ADDENDUM

Reference: Building 1190 Remodel Camp Williams
Utah National Guard
DFCM Project No. 06012480

Subject: **Addendum No. 1**

TOILET ROOM FLOOR PLAN CHANGE

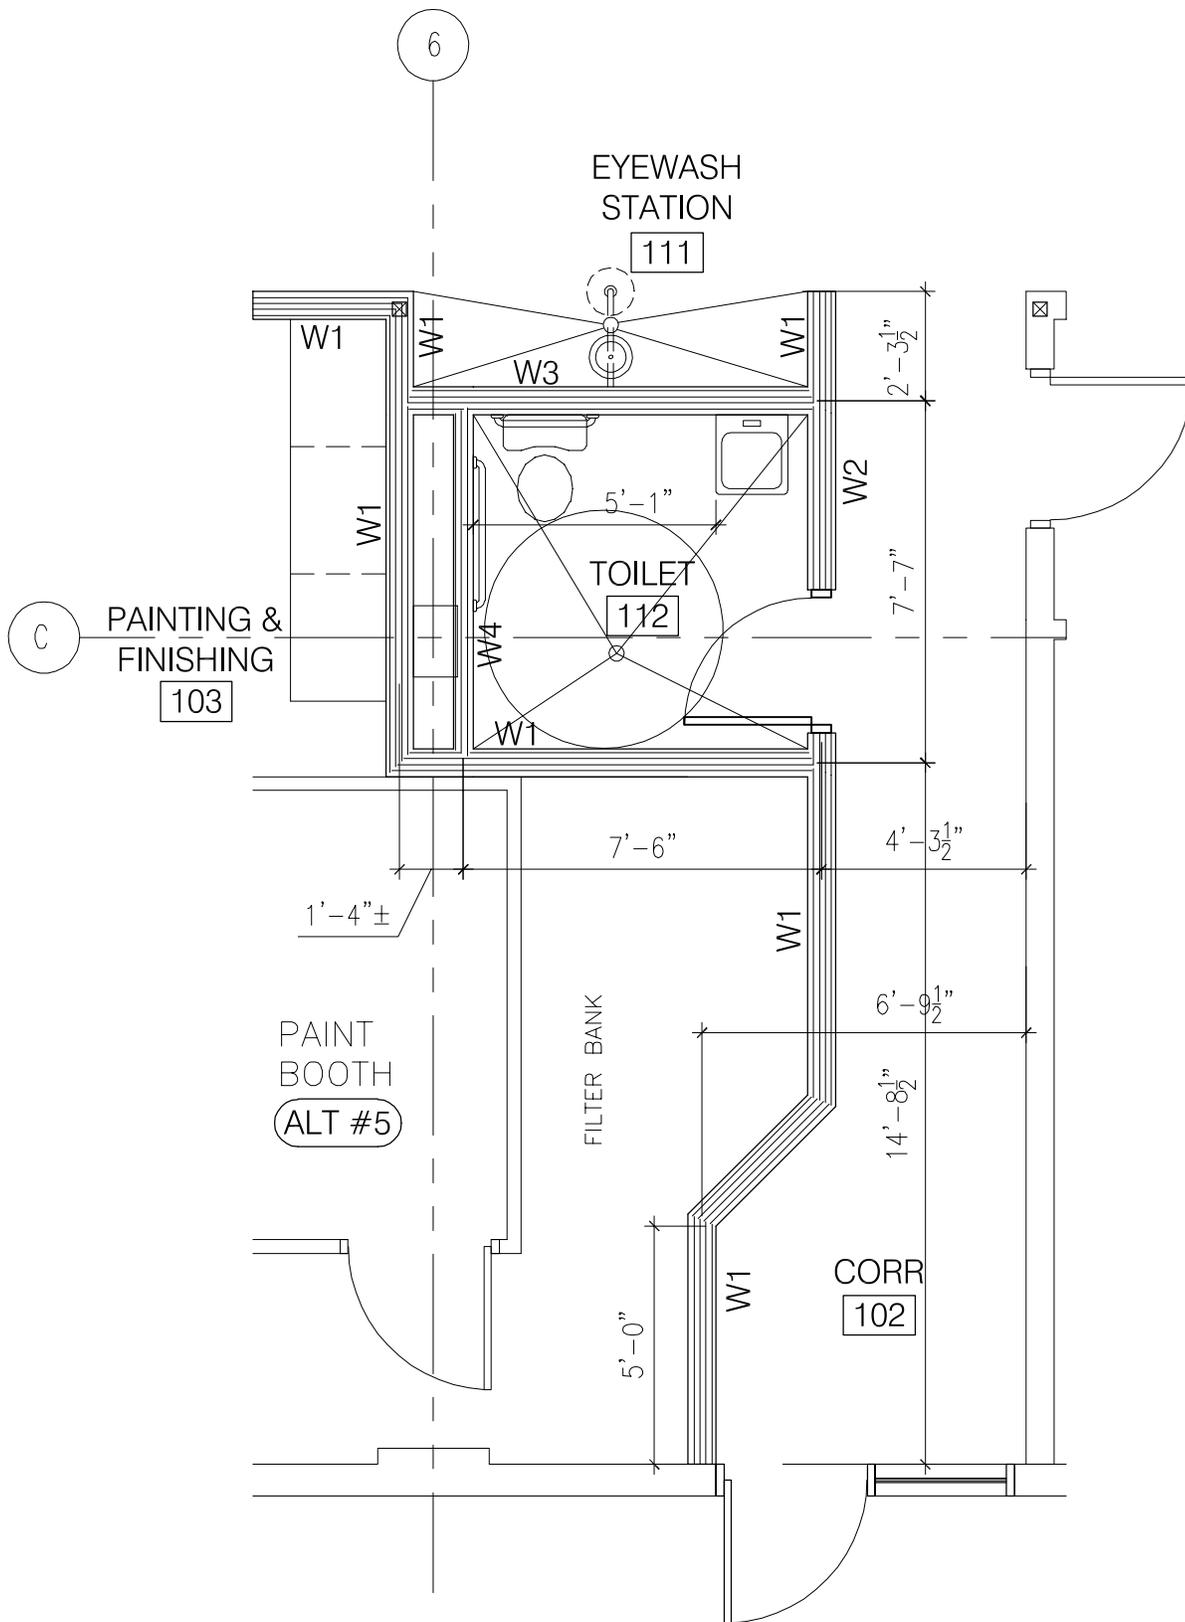
Sheet AE101

See the attached floor plan modification drawing for the Toilet Room 112 area. Move the west wall of Corridor 102 1-foot to the east. This will add 1-foot additional width to Toilet Room 112 to allow ADA compliant clearance between the sink and the wall.

This wall relocation will require coordination and modification of the scope of work shown on other drawings, including, but not limited to, space areas, interior finishes, plumbing, HVAC, electrical and communications systems, ETC. The scope of construction shall include the work required for this change.
